[Docket No. 2001-SW-74-AD; Amendment 39-12626; AD 2001-26-55]

Airworthiness Directives; Eurocopter France Model AS350B, AS350B1, AS350B2, AS350BA, AS350B3, AS350C, AS350D, AS350D1, AS355E, AS355F, AS355F1, AS355F2, and AS355N Helicopters

ACTION: Final rule; request for comments.

Figure 1

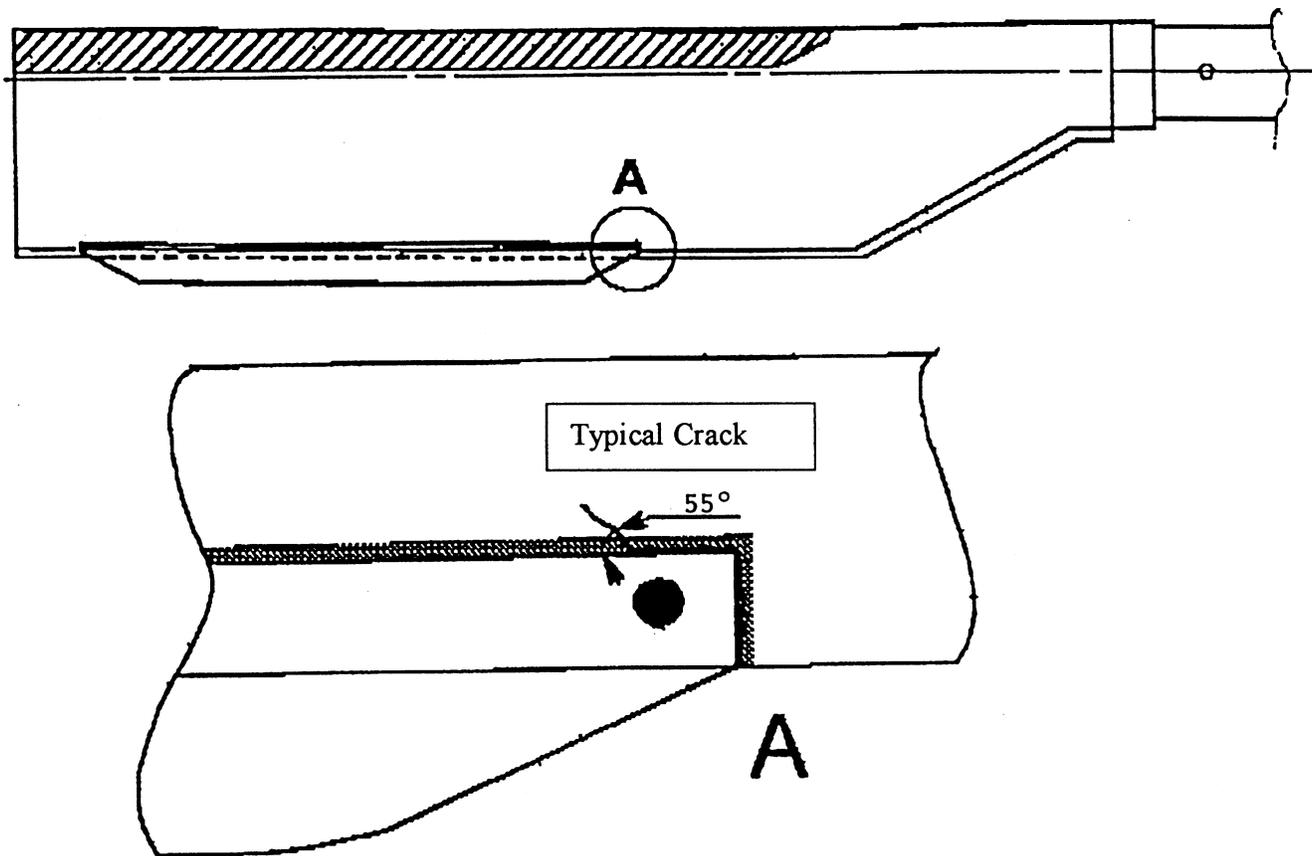
(a) Before further flight, and thereafter before the first flight of each day or at intervals not to exceed 10 hours time-in-service (TIS), whichever occurs first, visually check both sides (front and back) of each blade skin in the area of the trailing edge tab for a crack as shown in Area A of Figure 1 of this AD.

(c) If in doubt about the existence of a crack in the blade skin, clean the area and then inspect with a 6× or higher magnifying glass.

(d) If a crack is visible in the caulking, remove the caulking with 200-grit abrasive paper, taking care not to sand the skin. Inspect the blade skin for a crack using a 6× or higher magnifying glass.

(e) If a crack is found in the blade skin, replace the blade with an airworthy blade before further flight.
